We appreciate the opportunity of reviewing a draft copy of document SD-BWI-TS-007, "Applicability of the Van der Kamp Method in Slug Test Analysis." The report has been examined by the hydrogeology staff of the Division of Waste Management; by Golder Associates, Inc.; and by Roy Williams and Associates, Inc.. This letter transmits to you the comments of the NRC staff. Also, attached for your information are copies of the comments from Golder Associates and Roy Williams and Associates.

TO: Mark Logsdon
FROM: Jerry Rowe
SUBJECT: Contract No. NRC-02-82-045
BWIP Hydrogeology
Review of Van der Kamp Method
Letter No. 57

Review of
APPLICABILITY OF THE VAN DER KAMP METHOD
IN SLUG TEST ANALYSIS

Figure 1

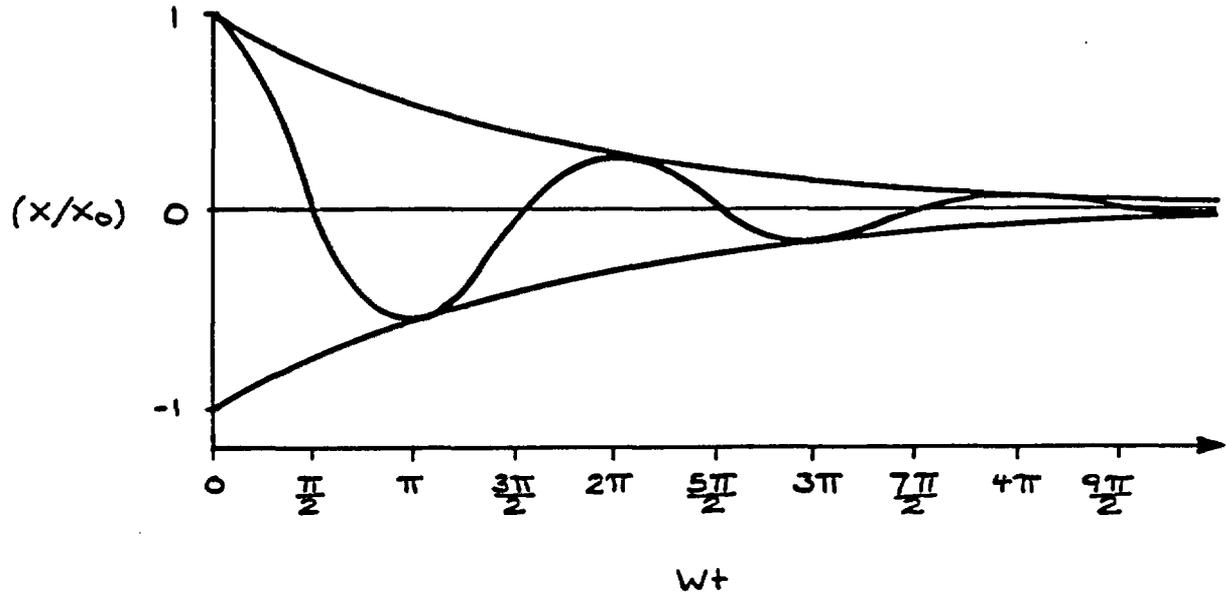
Analyses were conducted to estimate the effect of frictional losses in the wellbore. The typical underdamped response shown in Figure 1 is described by the equation

Differentiating (1) with respect to time and noting that the maximum slope of the oscillating response in Figure 1 occurs at $\omega t = (2n-1)\pi/2$, where $n = 1, 2, 3, \dots$, an expression for maximum velocity is obtained,

Figure 2

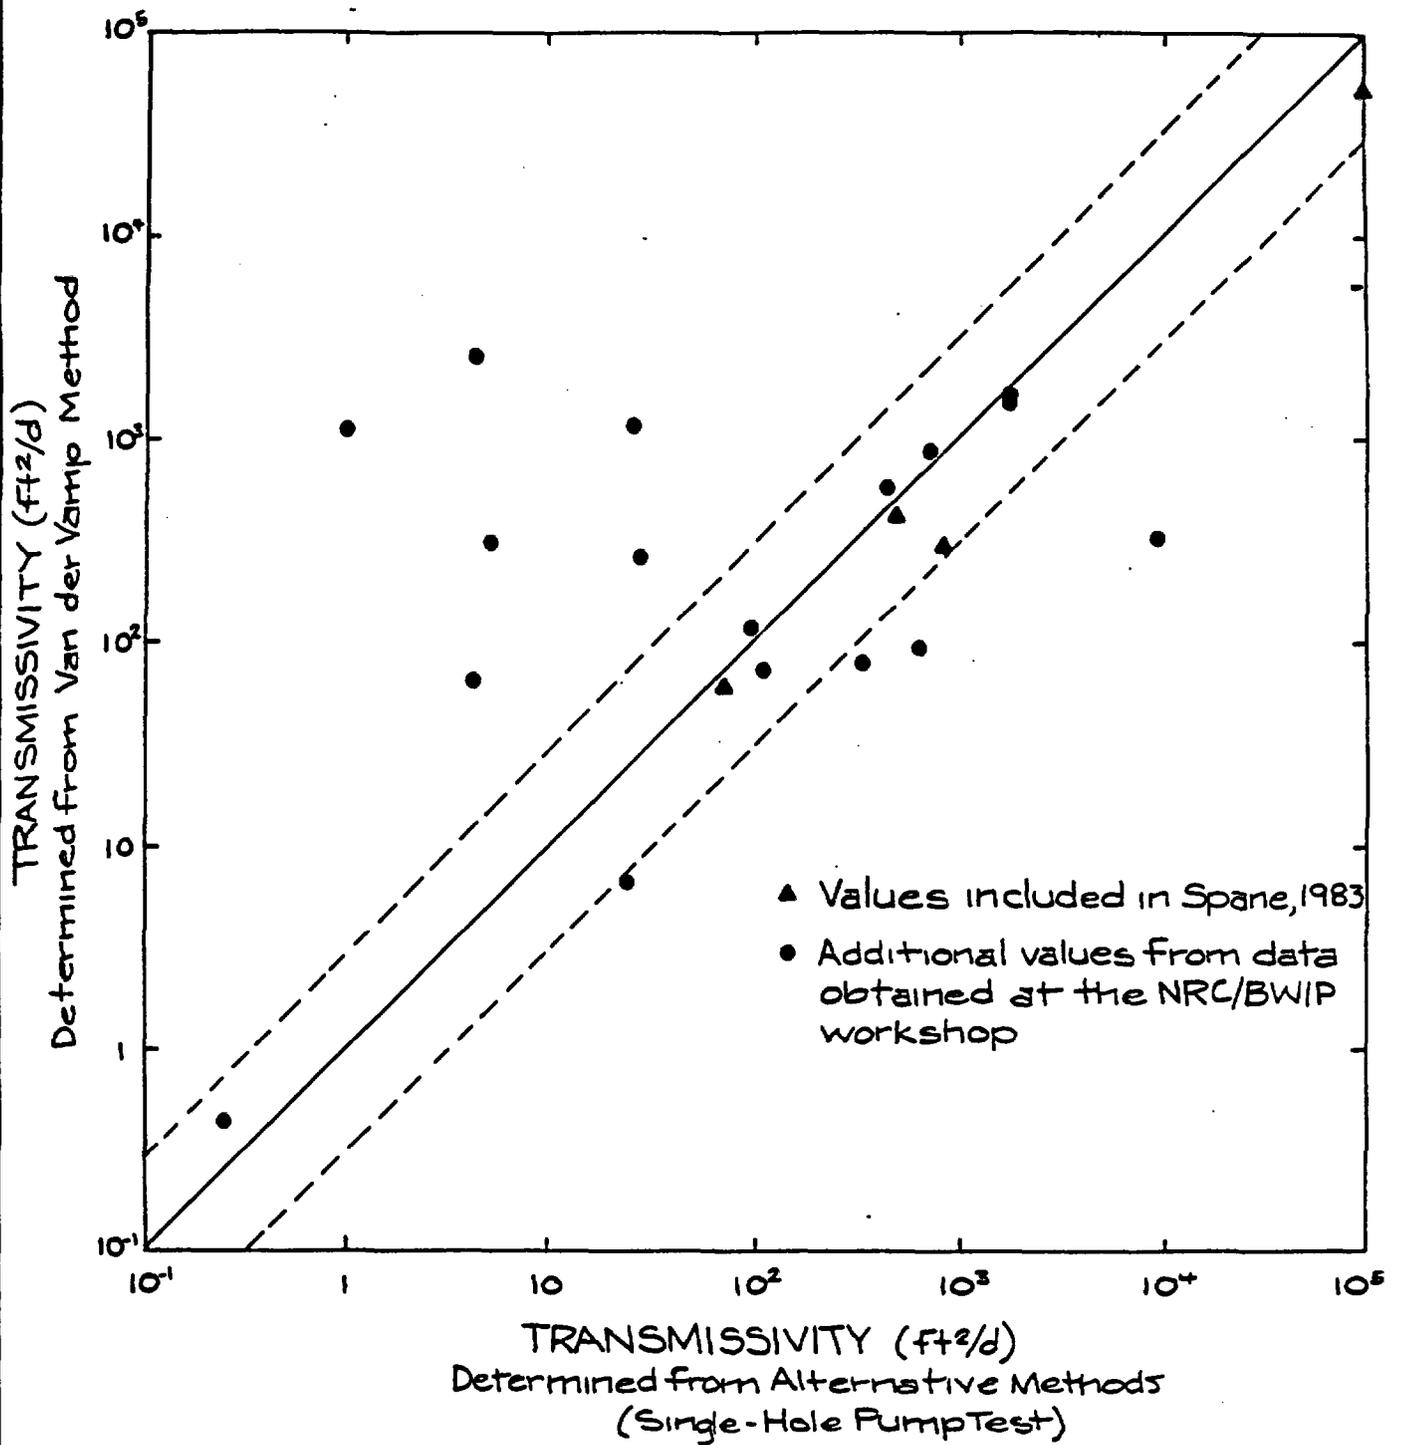
The transmissivity values determined by the Van der Kamp method are plotted versus values determined by alternative methods (e.g., single-hole pump tests) in Figure 2. The solid line represents a one-to-one correspondence between values determined by both methods while the dashed lines represents a factor of three difference. Of the twenty-one tests plotted on Figure 2, eleven fall within the factor of three range. However, a number of points fall well outside the range. We do not have the information to determine whether these results can be explained by careful examination or re-analysis of the test data.

The obvious conclusion is that in many cases, the values of transmissivity determined by the Van der Kamp method are significantly different from those determined by other methods and that one must question the validity of the results. Furthermore, in zones where the Van der Kamp method was used exclusively (twelve such zones are indicated in Table 3) it is questionable whether the values of transmissivity are meaningful estimates.

Where alternative testing methods suggest relatively low transmissivities in Figure 2 ($T < 30 \text{ ft}^2/\text{day}$), it is interesting to note that six of eight Van der Kamp values lie well above the 1:1 correlation line. This apparent over-estimation of transmissivity may indicate instances where the underdamped response was dominated by wellbore characteristics. In these cases, sole use of the Van der Kamp method could have led to erroneous conclusions regarding site conditions.

Where alternative testing methods suggest relatively high transmissivity ($T > 30 \text{ ft}^2/\text{day}$), ten of thirteen Van der Kamp values are below the 1:1 correlation line. In these cases, frictional head losses in the riser pipe may have caused the Van der Kamp method to underestimate aquifer transmissivity.

FIGURE 1. Expected Well Response Behavior for Slug Tests Conducted Under Common Hanford Test Conditions. (Figure 8)

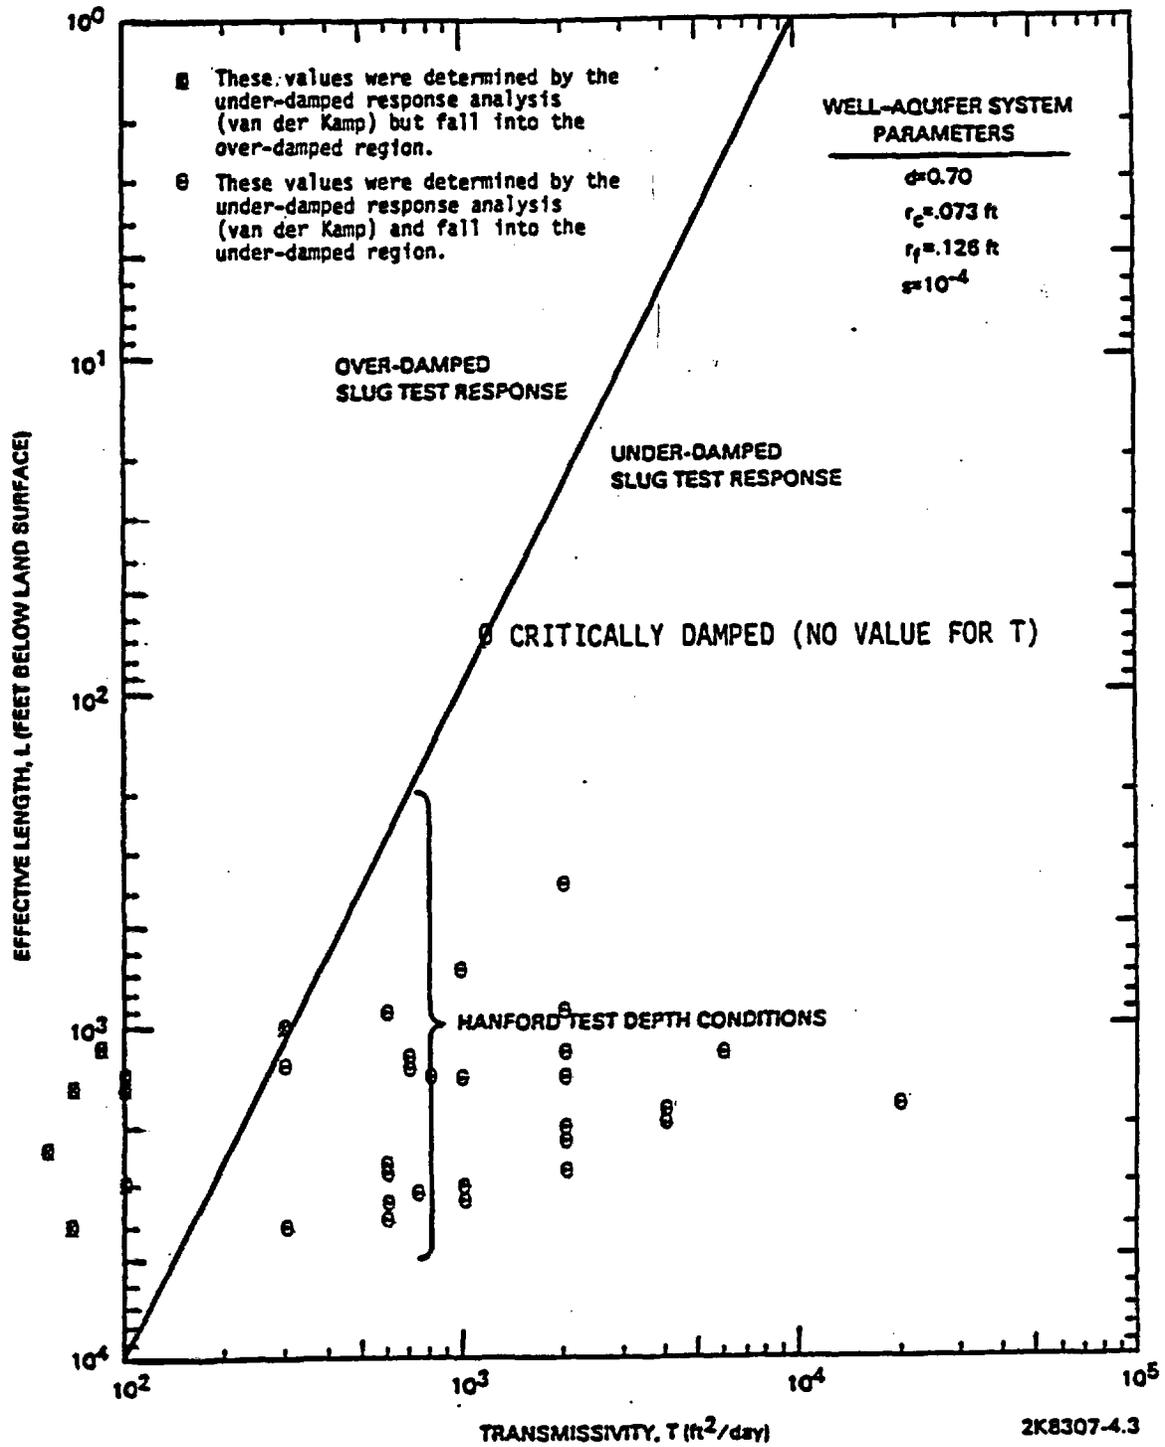
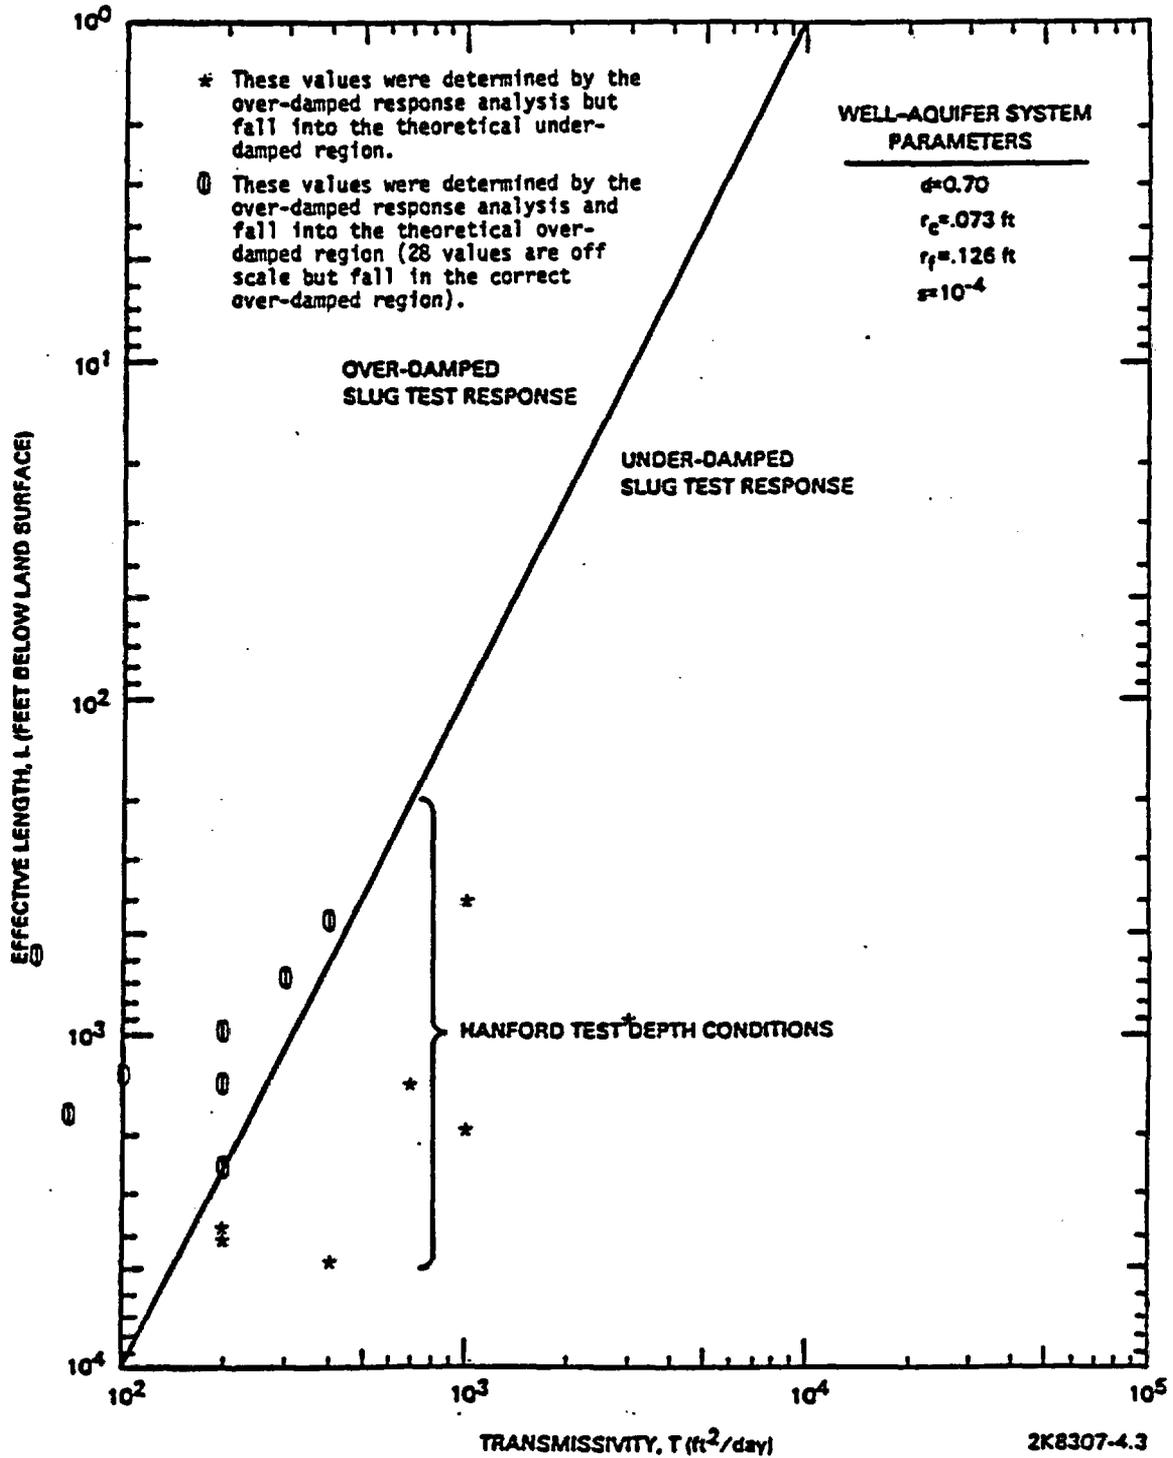
Figure 8 of the document under review (p. 21) shows that the van der Kamp method should yield no values of transmissivity below a threshold limit of 10^2 ft²/day on the Hanford site for the conditions specified by Dr. Spane. We plotted the actual transmissivities determined from the van der Kamp method versus the approximate length of the water filled tubing on Figure 1 (modified from Rockwell's Figure 8). We obtained these data during the July 1982 workshop held in Richland, Washington. We obtained 7 transmissivity values out of a total of 35 that were calculated based upon an under-damped water level response (van der Kamp mehtod) that plot in the over-damped (wrong) region of Figure 1. We also plotted on Figure 2 17 of the 45 transmissivities obtained at the workshop that were determined using the over-damped water level response method. Seven of these transmissivity values calculated based on an over-damped response fall in the under-damped (wrong) region of this figure. Twenty-eight of the transmissivity values obtained at the workshop could not be plotted on Figure 2 since these transmissivity values were less than 10^1 ft²/day. These values, if plotted, would fall in the correct portion of the graph. We believe that this figure exemplifies the uncertainty of this technique.
